# PLANNING AND ZONING CASE CHECKLIST City of Rockwall Planning and Zoning Department 385 S. Goliad Street Rockwall, Texas 75087

SP2019-030

**Project Name** 1480 Justin Road SITE PLAN

SP2019-030; Amended Site Plan for SPR Packaging

job no sheet A1.0

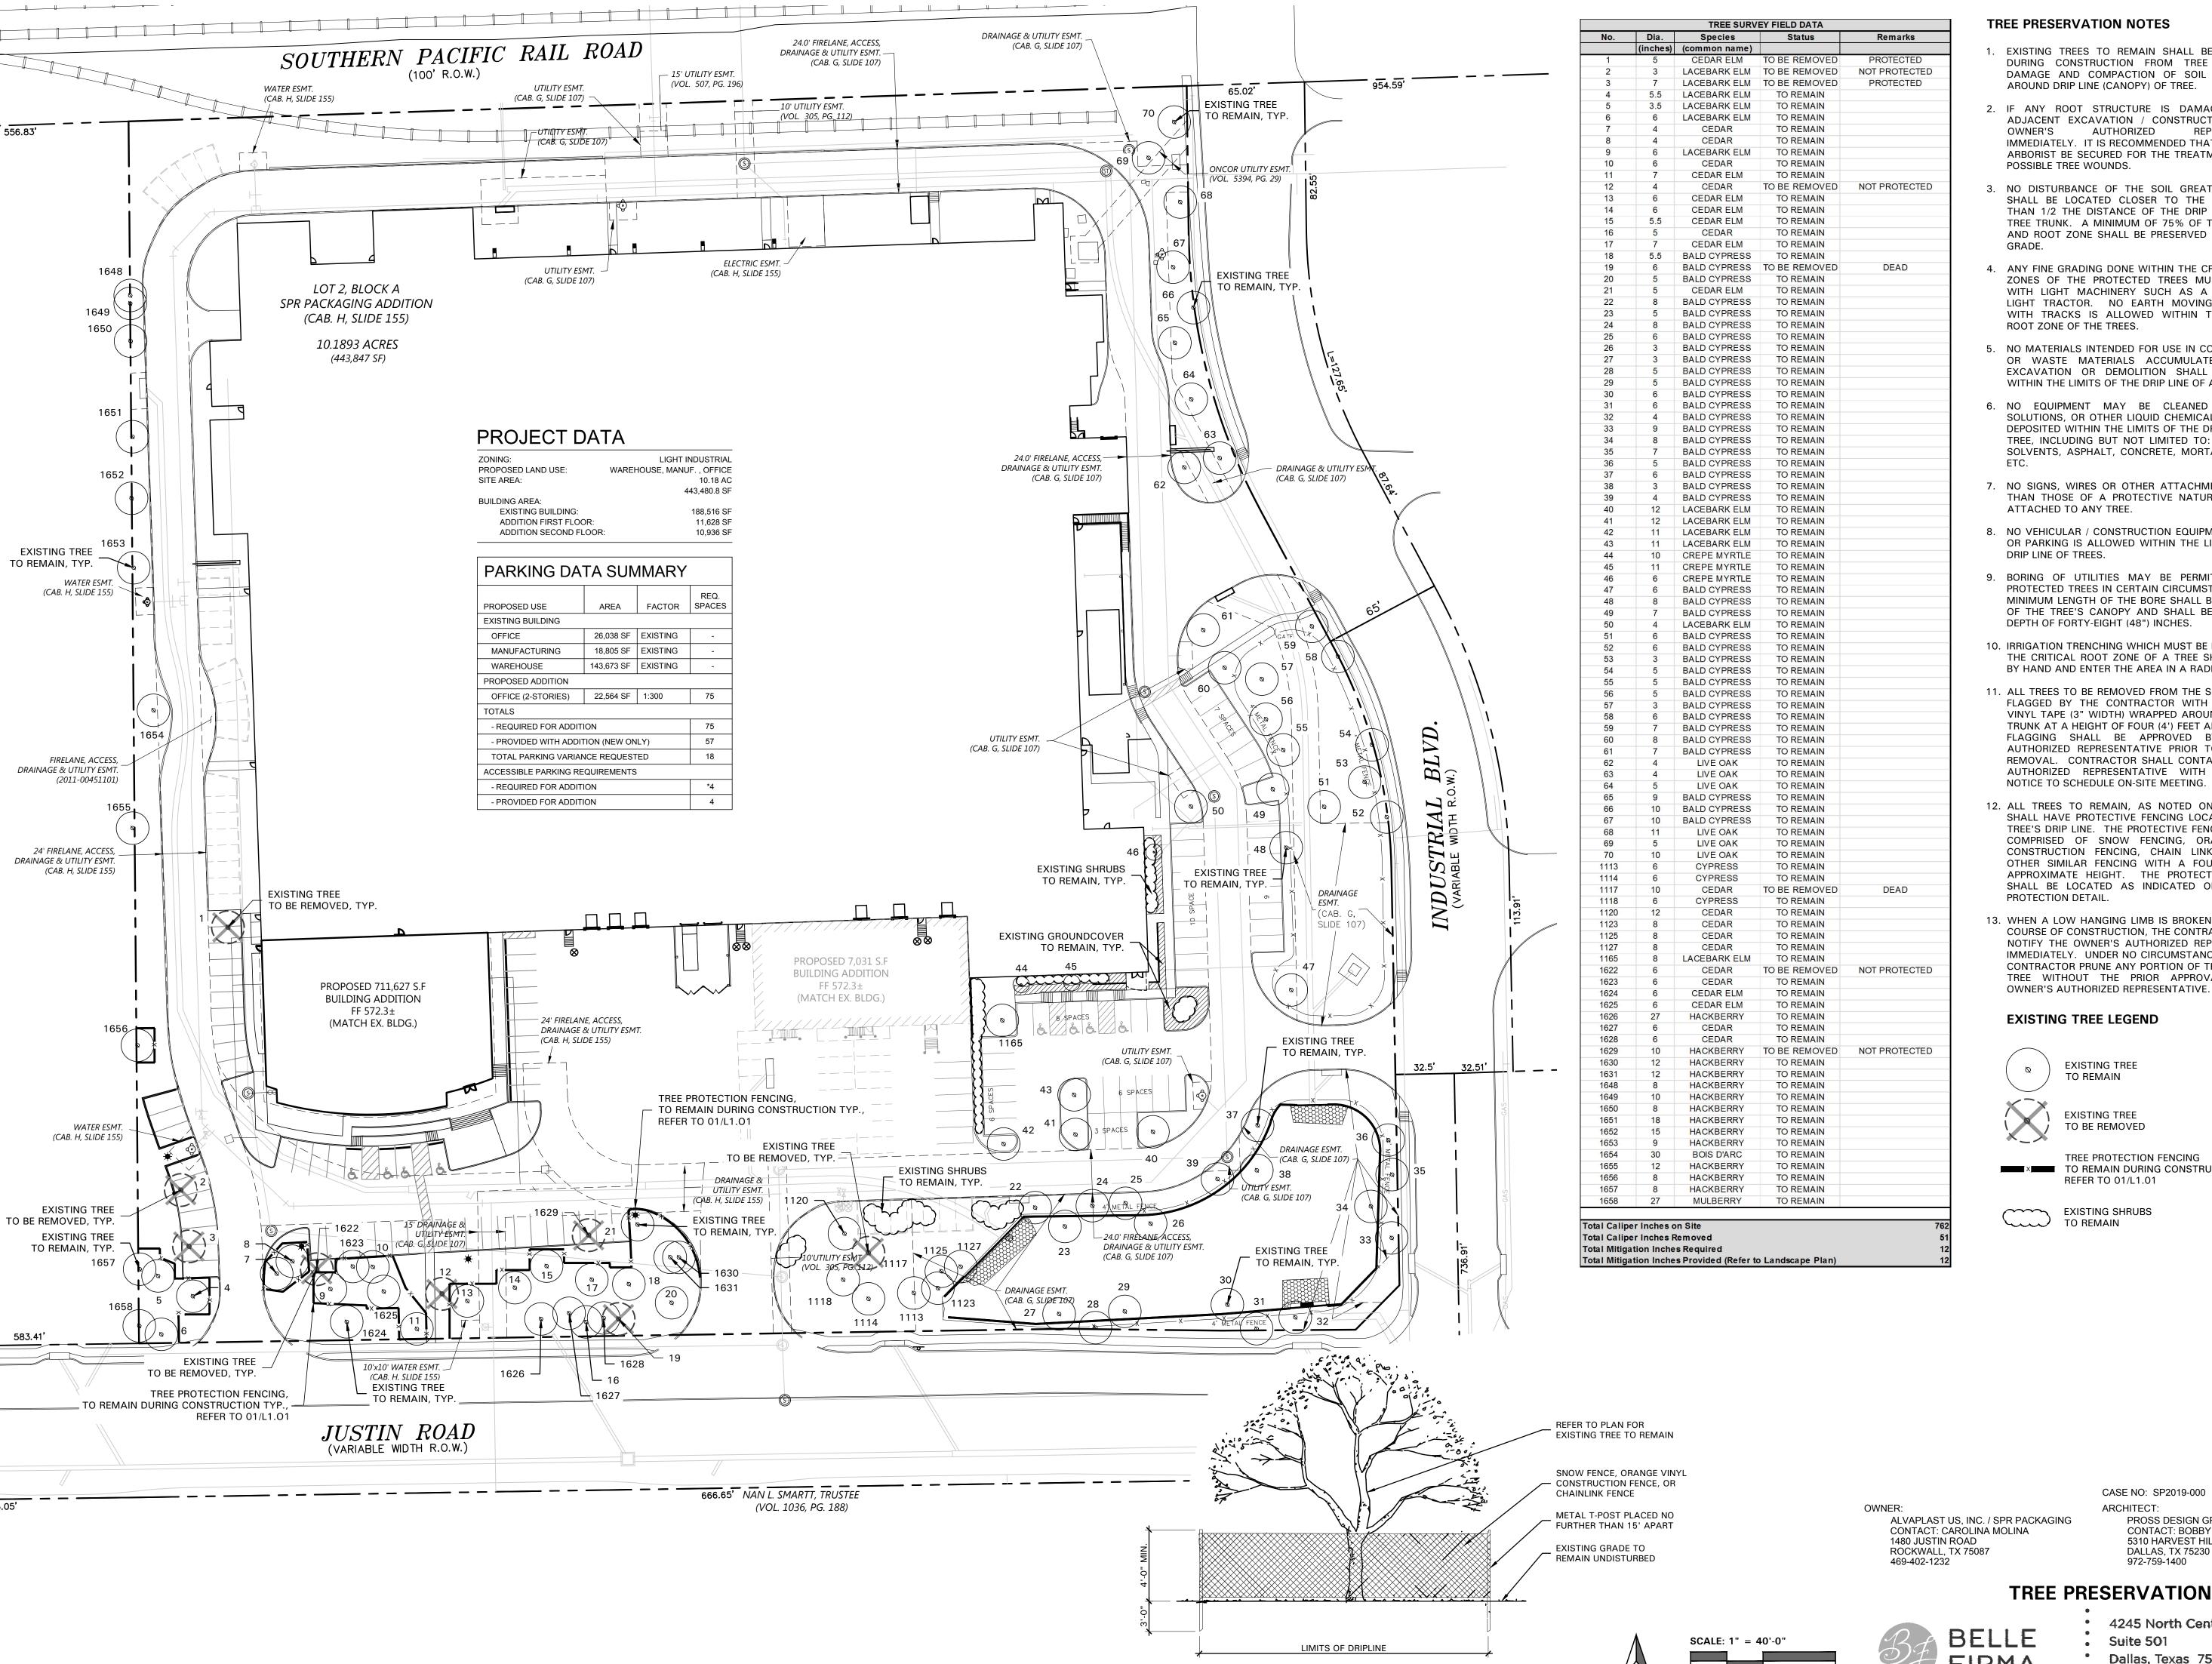
M.6 Site Plan. Please make the following clarifications on the site plan to ensure staff can properly review this project and convey all of the required elements to the City's boards and commissions:

- 1) Please provide a label to the parking count for the ten(10) spaces adjacent to the western portion of the proposed addition
- 2) Please remove the Legend that includes the concrete pavement thickness. This is to be determined by the engineering department during the civil submittal process and is not considered for review during this site plan process.

- 3) The proposed relocated dumpster enclosure is facing Justin Road According to Subsection 6.02, General Overlay District Standards, of Article V, District Development Standards, of the UDC, dumpster enclosures shall be located to the side or rear of the buildings and shall not front onto a public right-of-way. Please reposition the dumpsterenclosure so that it is not visible from public right-of-way or provide a screening plan showing how the proposed dumpster enclosure can be screened utilizing landscaping.

- 4) Parking for an office use requires a minimum of one (1) parking space per 300-SF (i.e. 1:300 SF) of gross floor area. The proposed 22,564 SF addition requires a minimum of 75 parking spaces. Approval of a variance to Section 5, Off-Street Parking Requirements, of Article VI, Parking and Loading is required by the Planning and Zoning Commission.

## TREE PRESERVATION PLAN

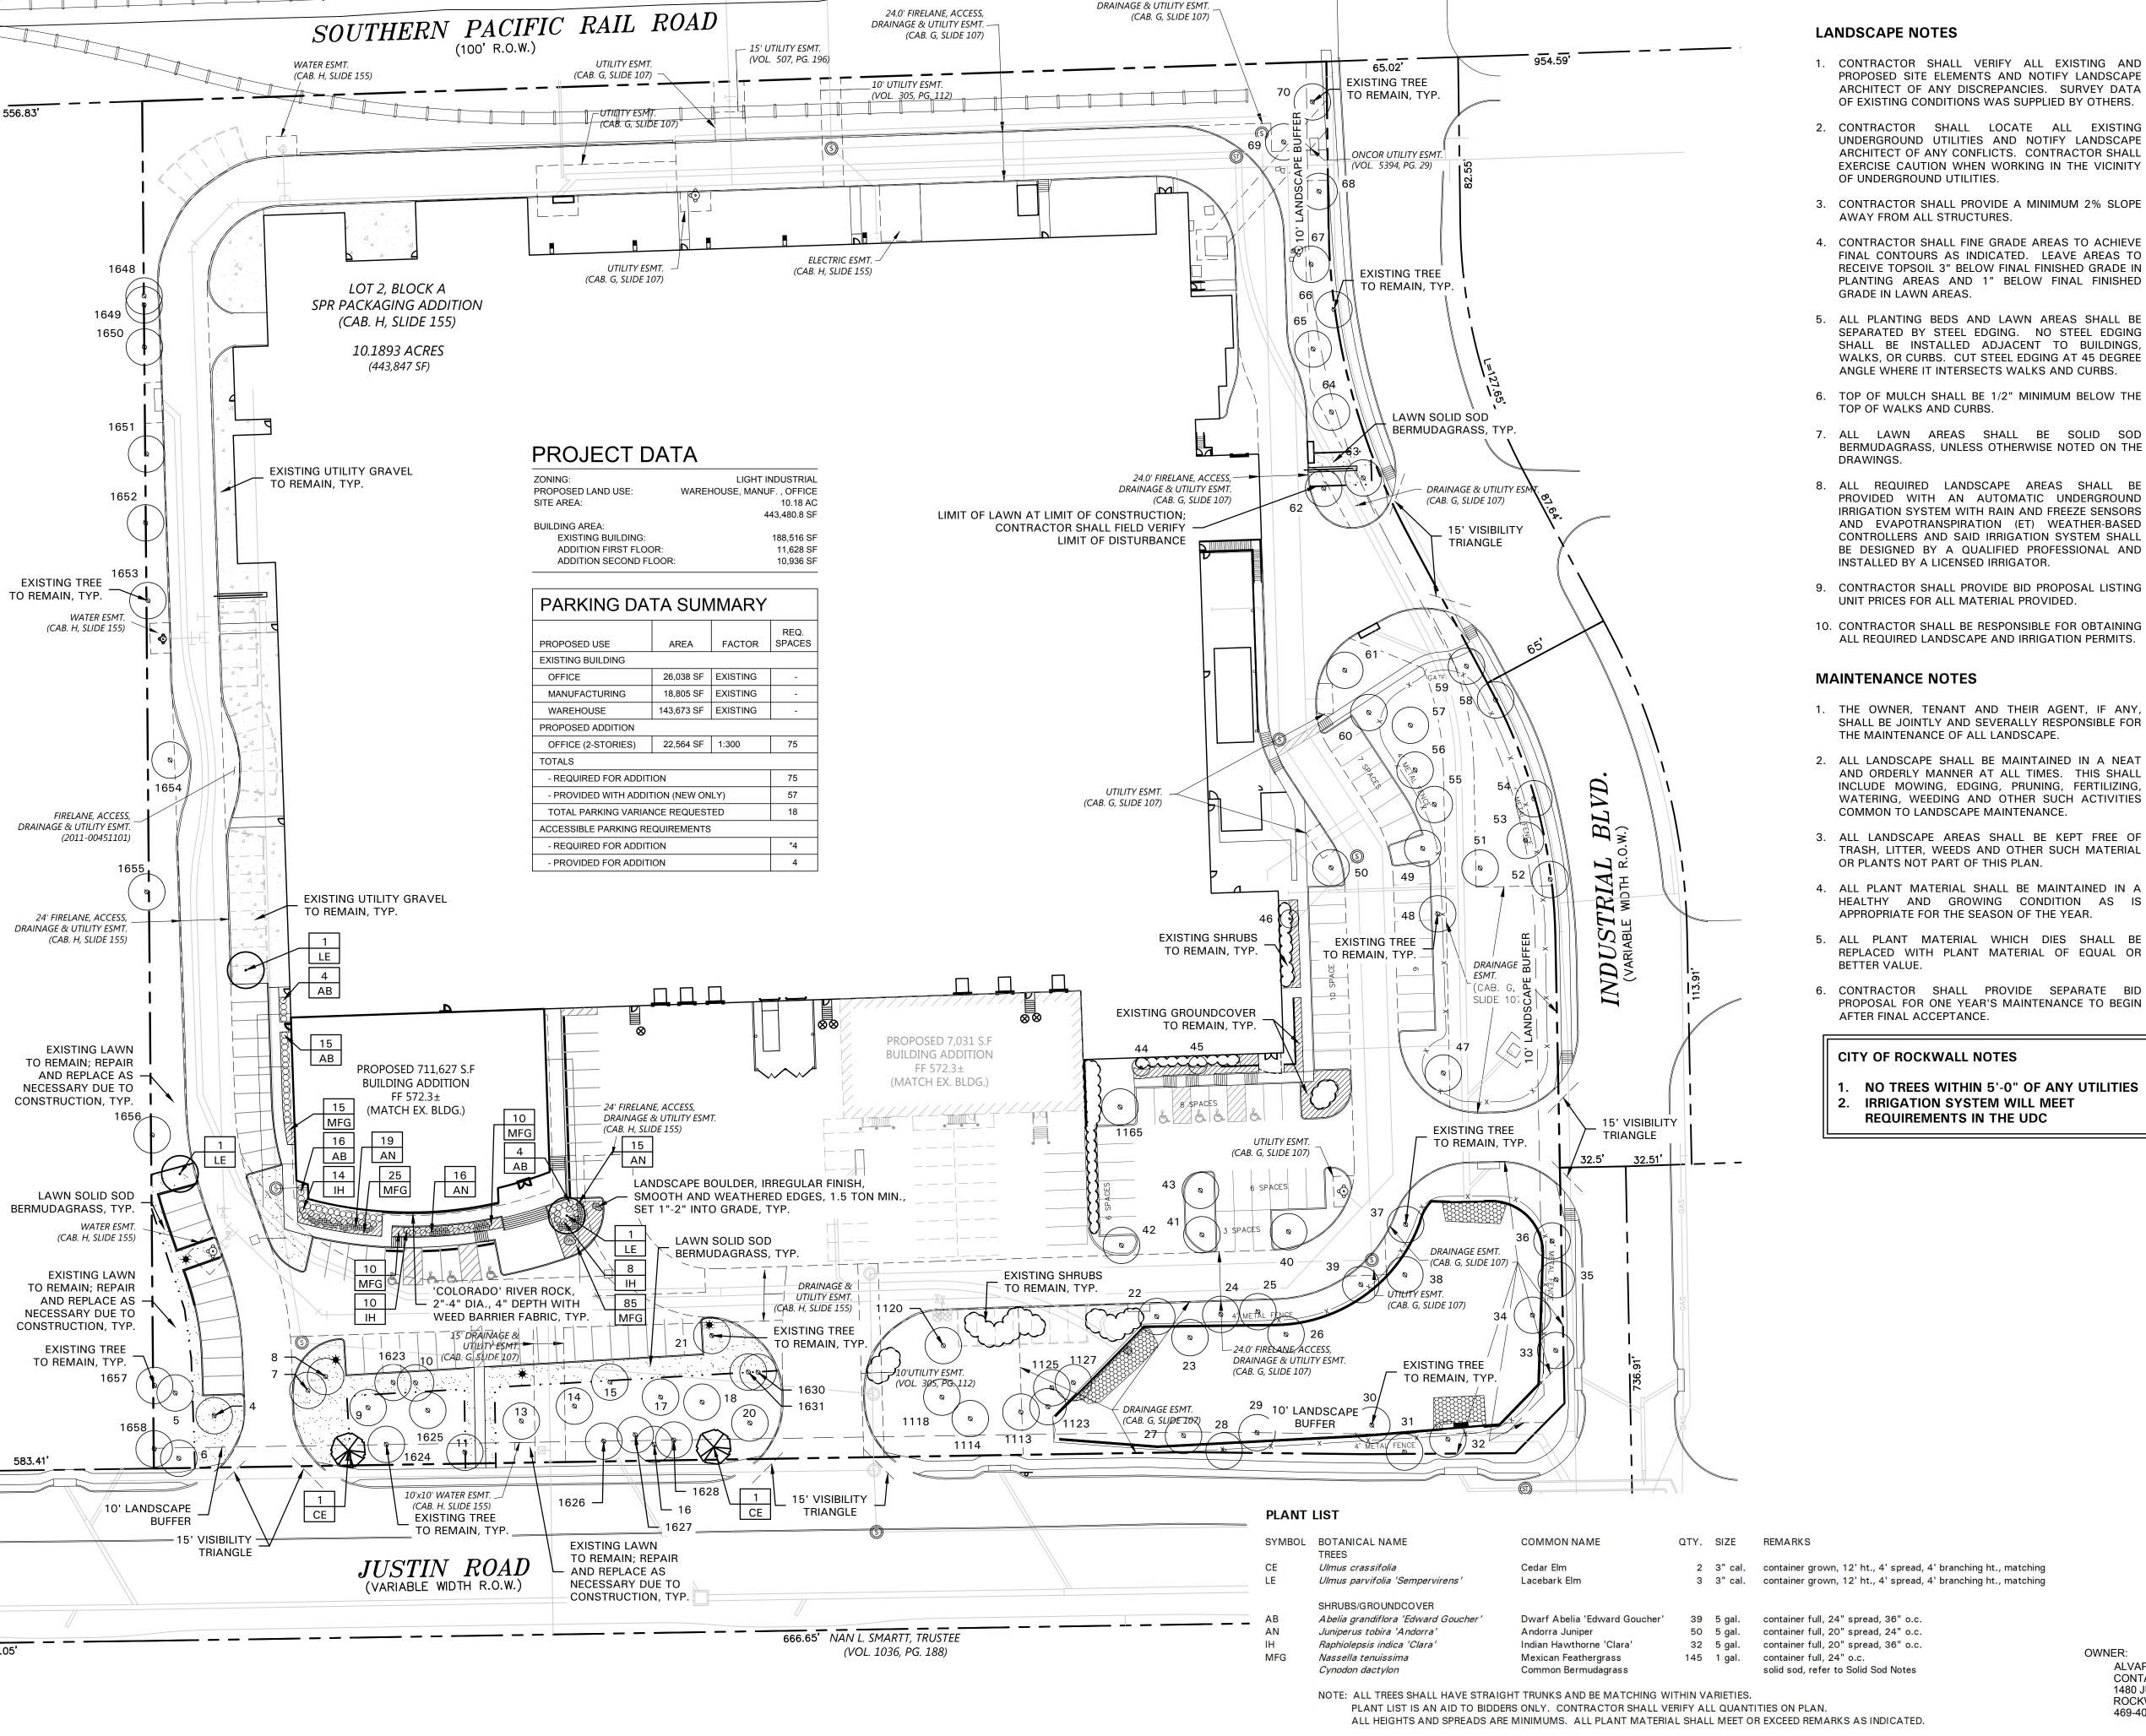
- 1) Please use a lighter gray scale to distinguish between the existing landscaping and the new landscape materials to be added
- M.13 Treescape Plan. According to Section 3.4, Treescape Plan Review Process, of Article IX, of the UDC, the director of planning and zoning, or his/her designee, shall review the treescape plan and approve the plan per the requirements of this article, or forward any recommendations to the planning and zoning commission. As part of the treescape plan review process, the city has the right to request changes or adjustments in the layout and design of a development to save trees. The planning and zoning commission will review and approve or disapprove the treescape plan. The decision of the planning and zoning commission may be appealed to the city council. The treescape plan requires approval by the Planning and Zoning Commission as submitted.
